# URBAN DESIGN COMMISSION APPLICATION CITY OF MADISON

1. Project Address: Phase II-800 North Block, East Washington Avenue (802, 854; Block 143)  
Project Title (if any): the Galaxie

Owner: Otto Gebhardt, Gebhardt Development  
Project Name: the Galaxie Phase II  
Purpose: UDC Design Progression Submission

# THE GALAXIE - PHASE II

DESIGN PROGRESSION

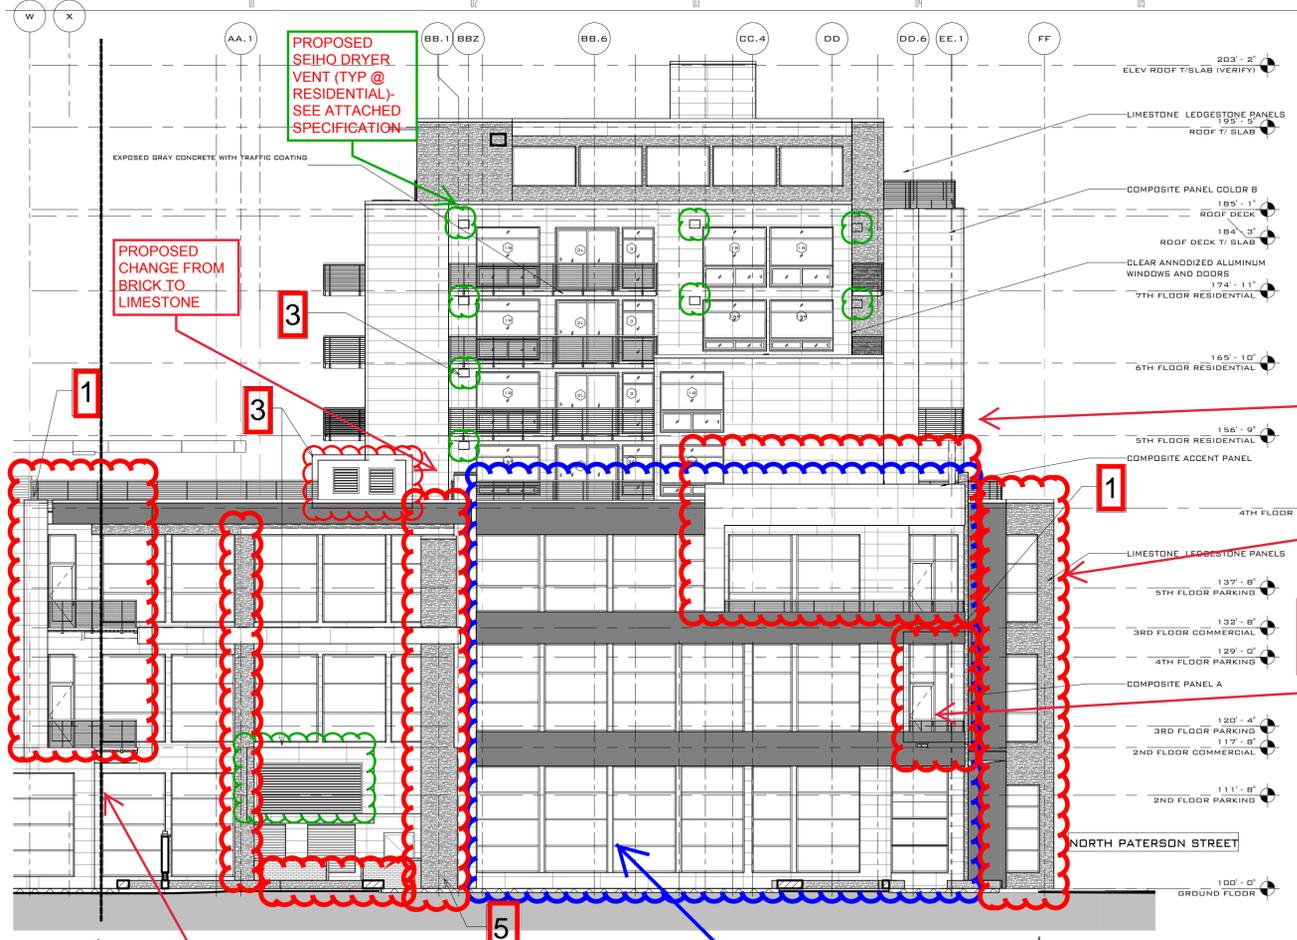
- ADDED BALCONIES ON SECOND AND THIRD FLOOR COMMERCIAL  
 REASON: FACILITATE TRANSITION BETWEEN PHASE I & II, AND TO FURTHER ACTIVATE EASTING WASHINGTON AND PATERSON

- MODIFY STOREFRONT FENESTRATION AT GROUND, SECOND, AND THIRD COMMERCIAL FLOORS  
 REASON: MODIFIED TO BETTER MEET TENANT BUILDOUT NEEDS
- ADDED LOUVERS AT COURTYARD AND OTHER LOCATIONS AS NOTED  
 REASON: VENTILATION OF GENERATOR DUE TO ENCLOSURE OF PARKING GARAGE AND COORDINATION WITH STRUCTURAL AND MECHANICAL

- PARKING ENCLOSURE CLADDING  
 REASON: ENCLOSURE OF PARKING GARAGE TO PROVIDE RESIDENTIAL TENANTS W/ HEATED PARKING
- COMMERCIAL CLADDING CHANGE FROM MODULAR BRICK TO LEDGESTONE, AND METAL ACCENT PANEL TO COMPOSITE ACCENT PANEL  
 REASON: MASSING MATERIAL REFINEMENT

- REVISED MASSING  
 REASON: UPDATED TURN LANE INFORMATION AT PATERSON STREET
- RELOCATED/ ADDED COMMERCIAL ENTRY DOORS  
 REASON: WORK WITH SITE GRADES AND PROVIDE GROUND FLOOR TENANTS WITH DIRECT ENTRY

**OVERALL EXTERIOR MATERIAL PALLETE--BRICK IS PROPOSED TO BE OMITTED AND REPLACED WITH LIMESTONE LEDGESTONE AND METAL PANEL REPLACED WITH CUSTOM PAINTED COMPOSITE PANEL--SYNSTONE IS PROPOSED FOR PARKING RAMP ENCLOSURE**

**A4.1**  
 BUILDING ELEVATIONS  
 NTS SCALE 3/32" = 1'-0"

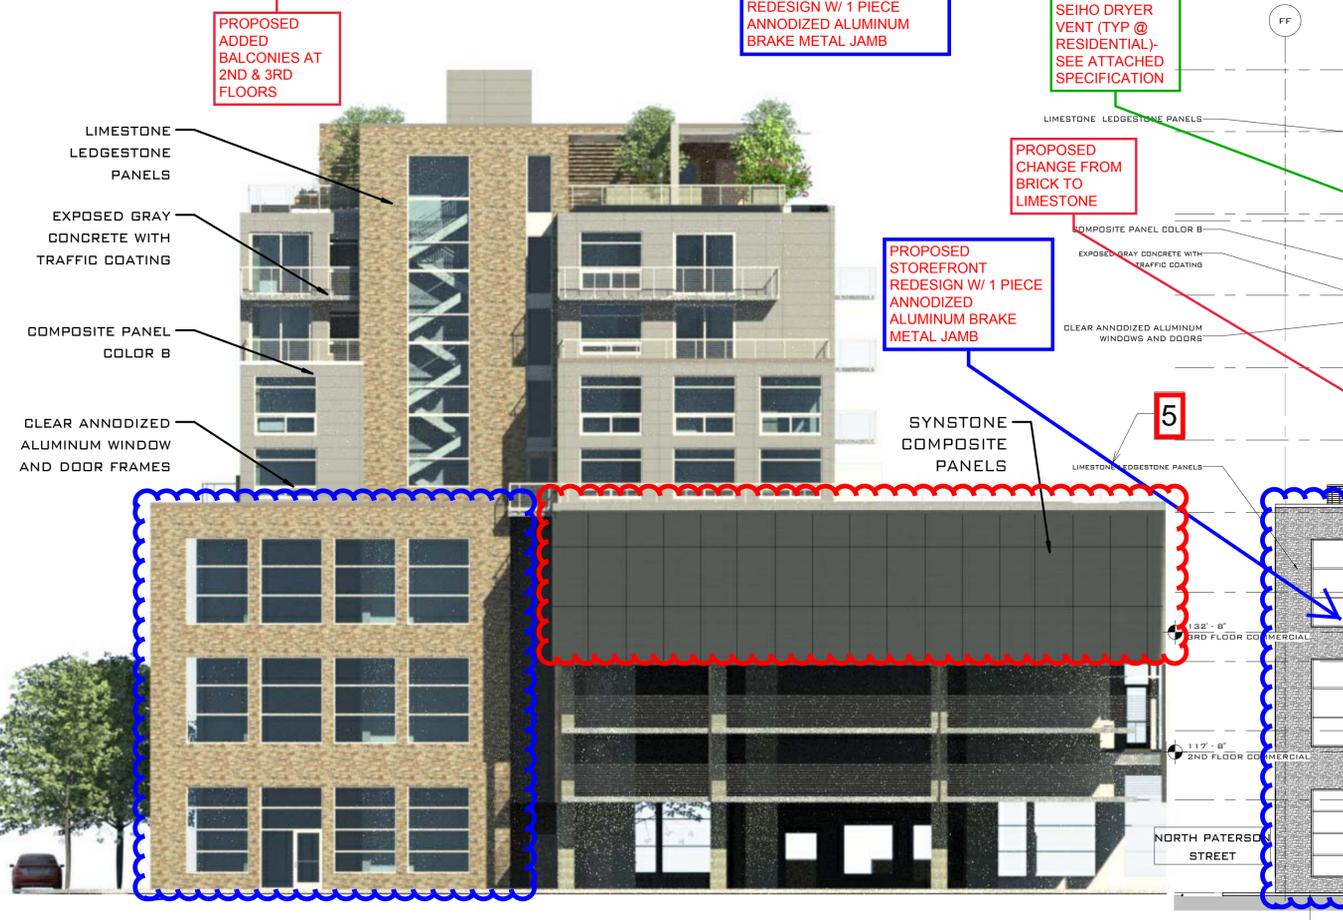
## EAST WASHINGTON ELEVATION

BACK ELEVATION

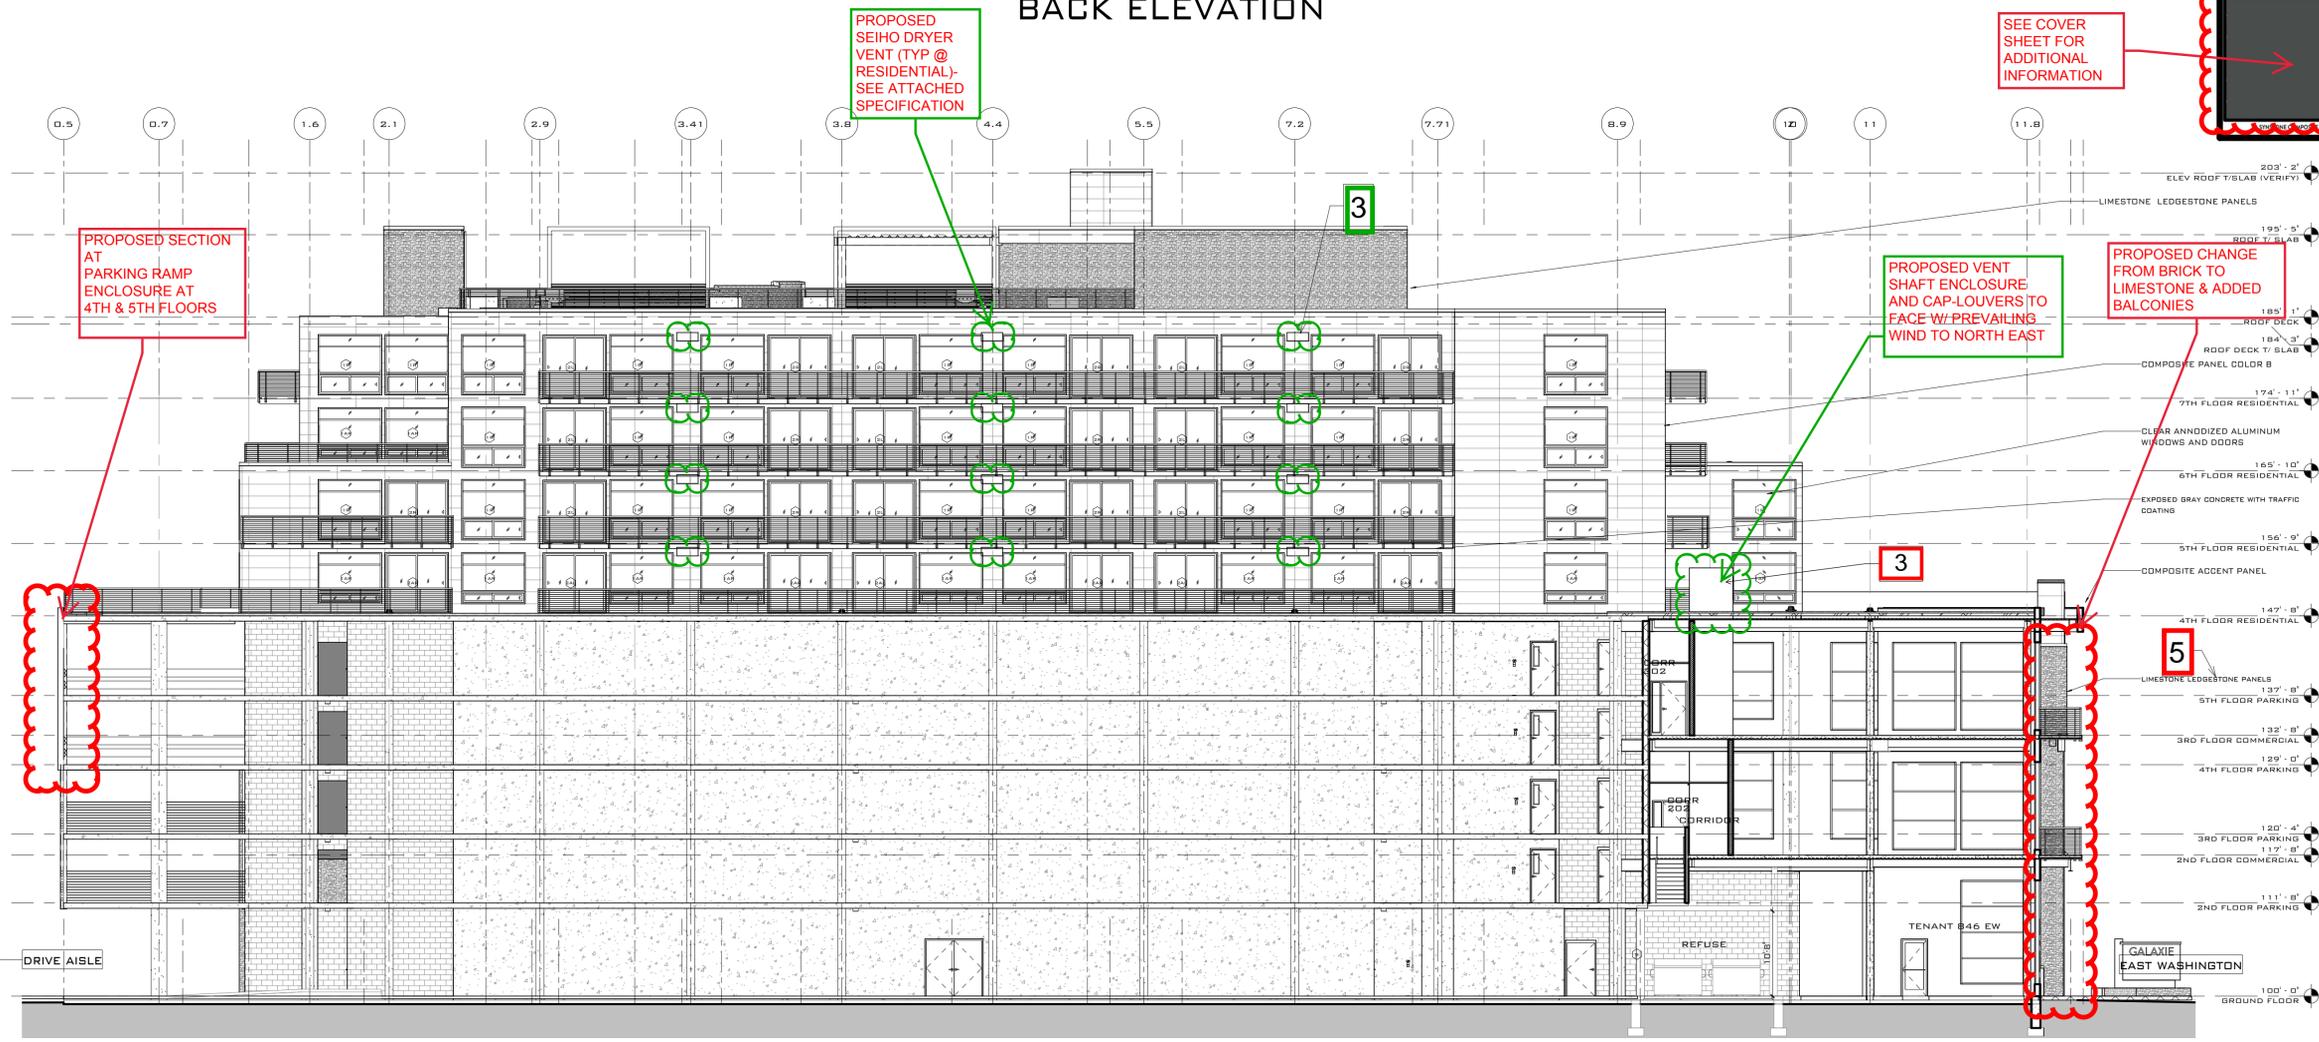
- LIMESTONE LEDGESTONE PANELS
- COMPOSITE PANEL COLOR B
- CLEAR ANNOIDIZED ALUMINUM WINDOW AND DOOR FRAMES
- EXPOSED GRAY CONCRETE WITH TRAFFIC COATING

NORTH PATERSON ELEVATION

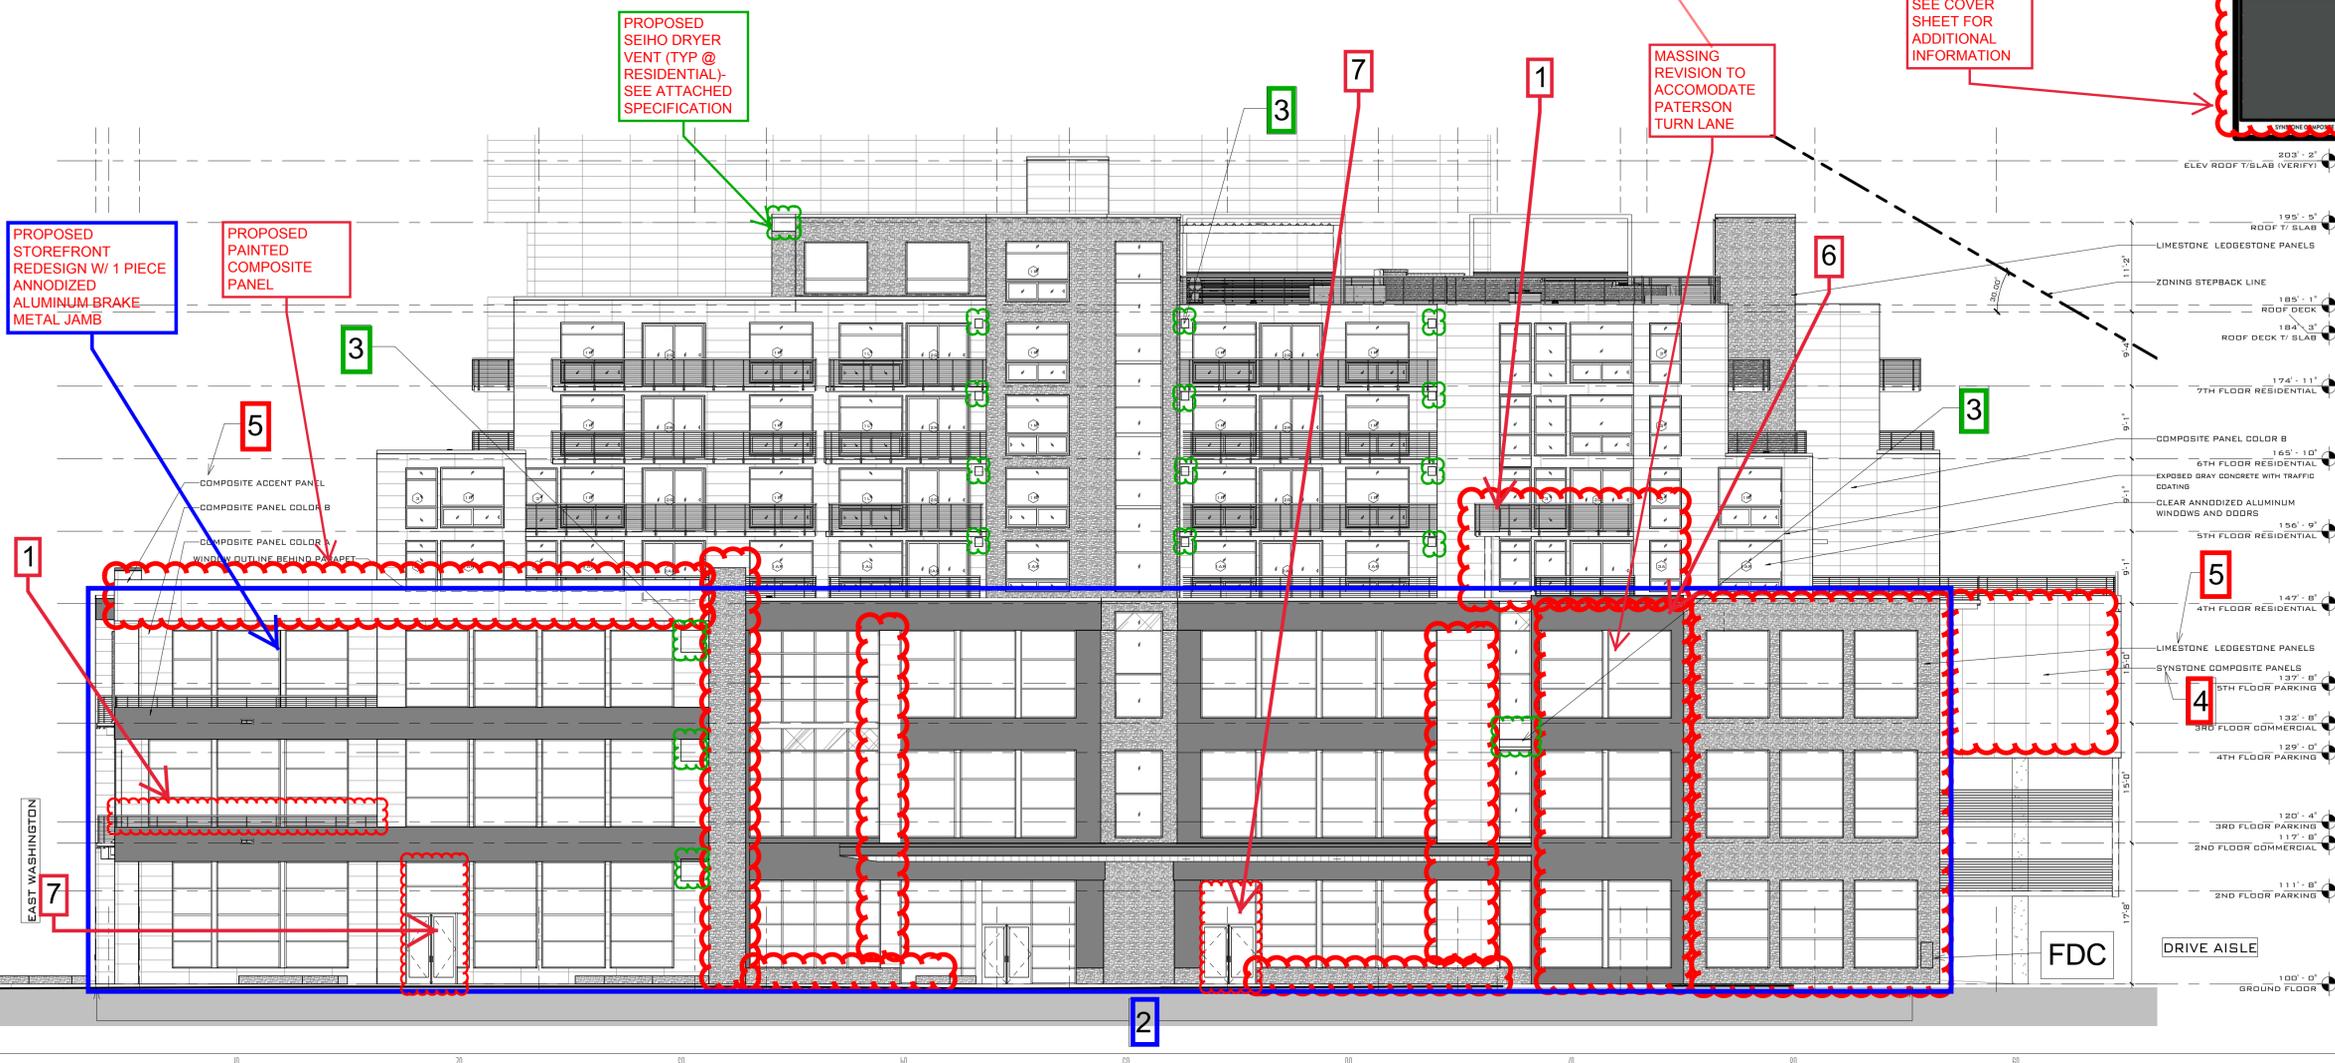
- LIMESTONE LEDGESTONE PANELS
- COMPOSITE PANEL COLOR B
- EXPOSED GRAY CONCRETE WITH TRAFFIC COATING
- CLEAR ANNOIDIZED ALUMINUM WINDOW AND DOOR FRAMES COMPOSITE PANEL COLOR A
- COMPOSITE ACCENT PANEL
- SYNSTONE COMPOSITE PANEL

VIEW FROM EAST WASHINGTON & NORTH PATERSON

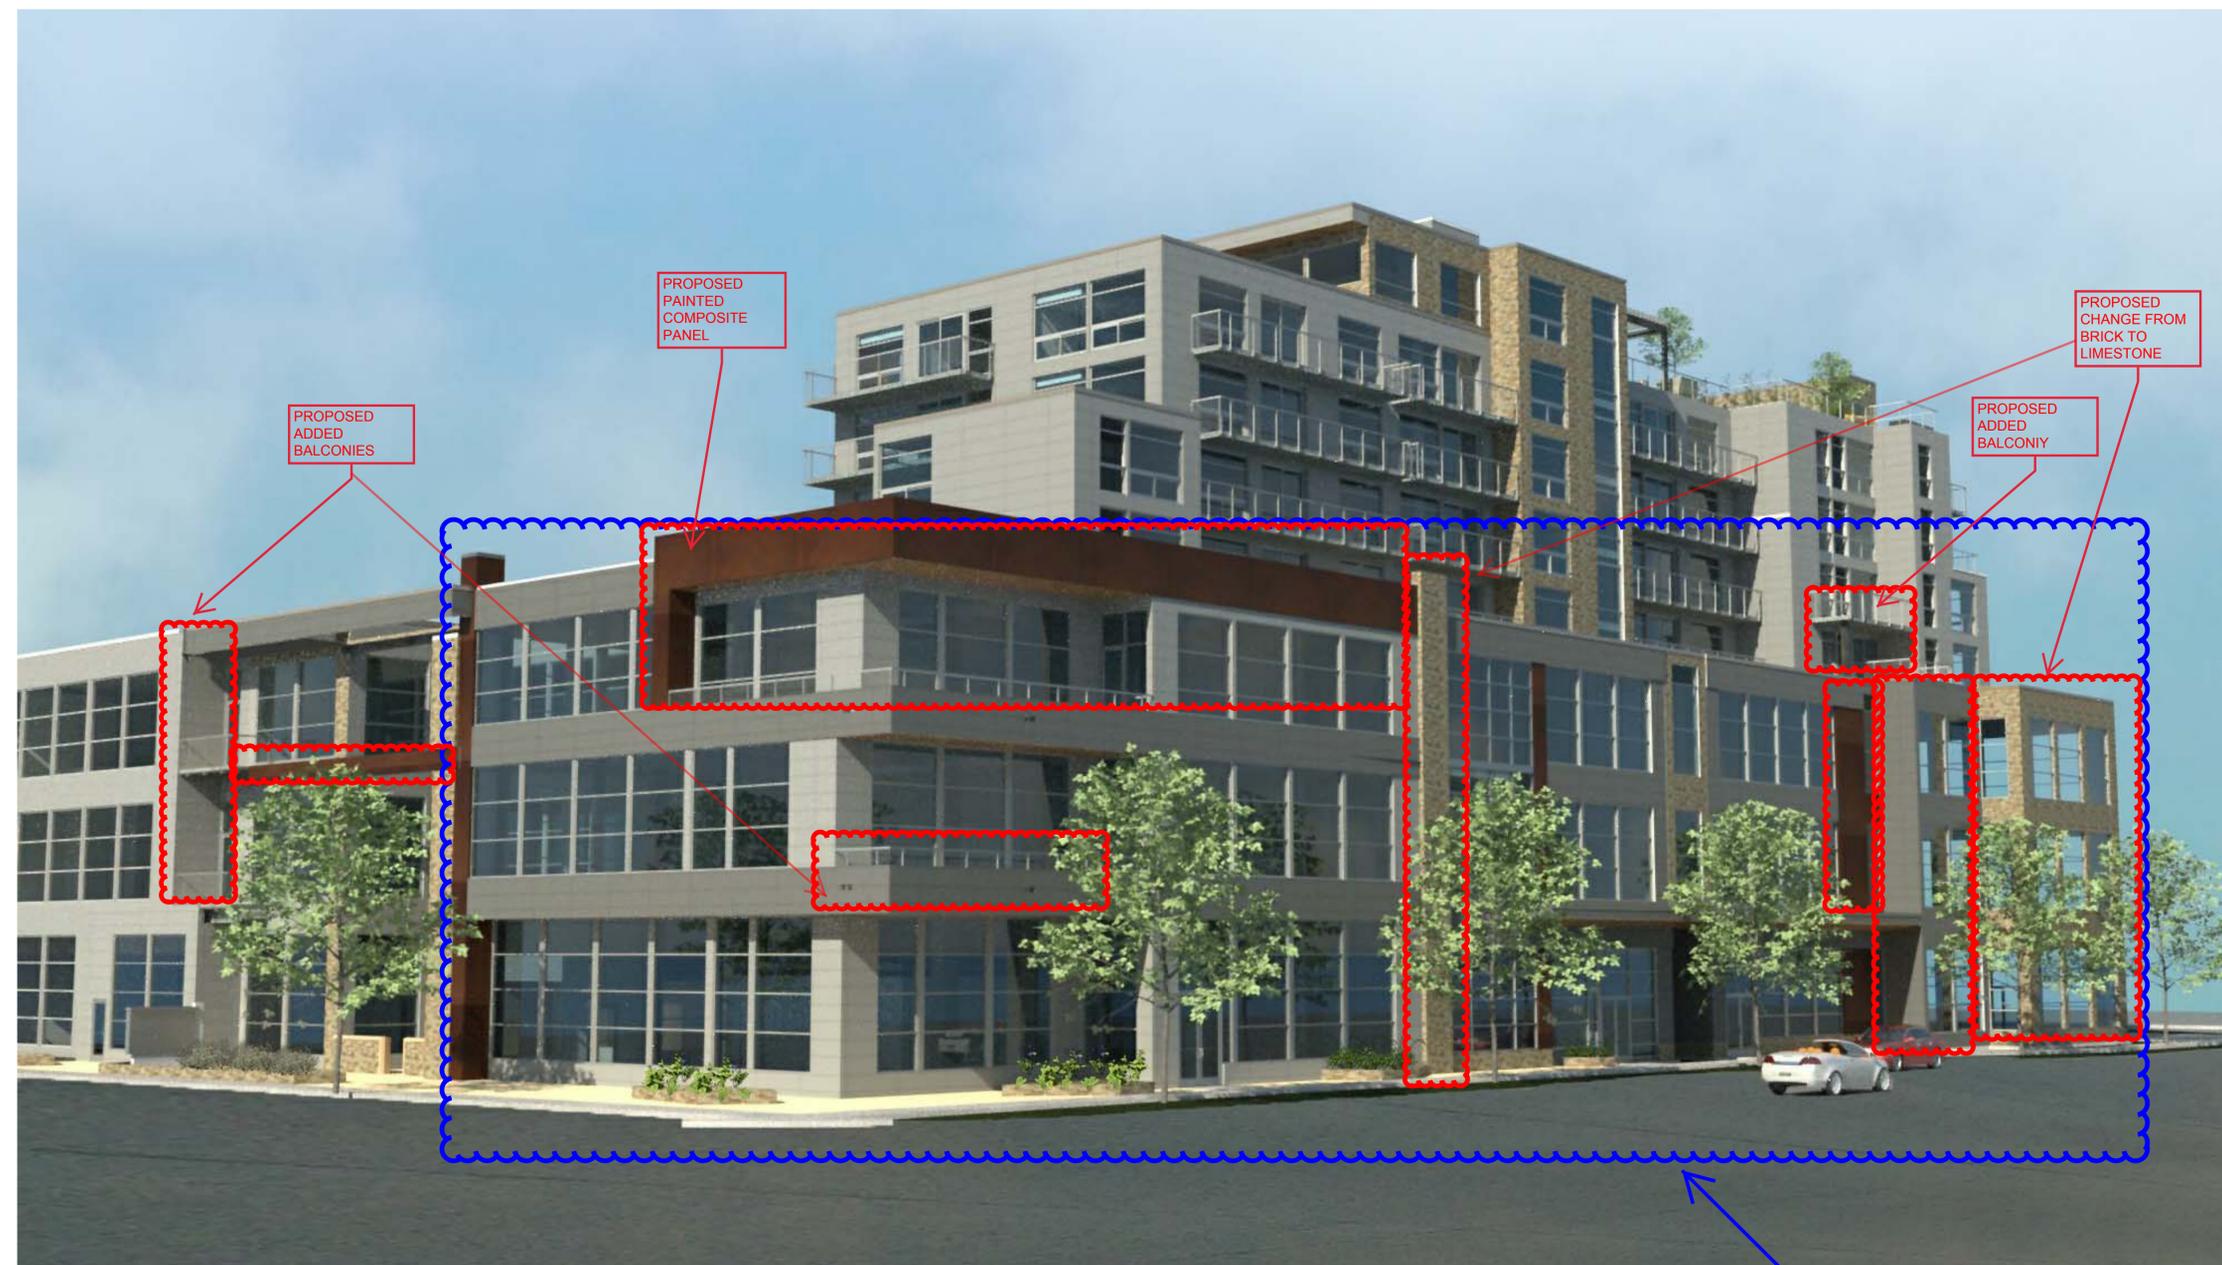
PROPOSED STOREFRONT REDESIGN W/ 1 PIECE ANNOXIDIZED ALUMINUM BRAKE METAL JAMB
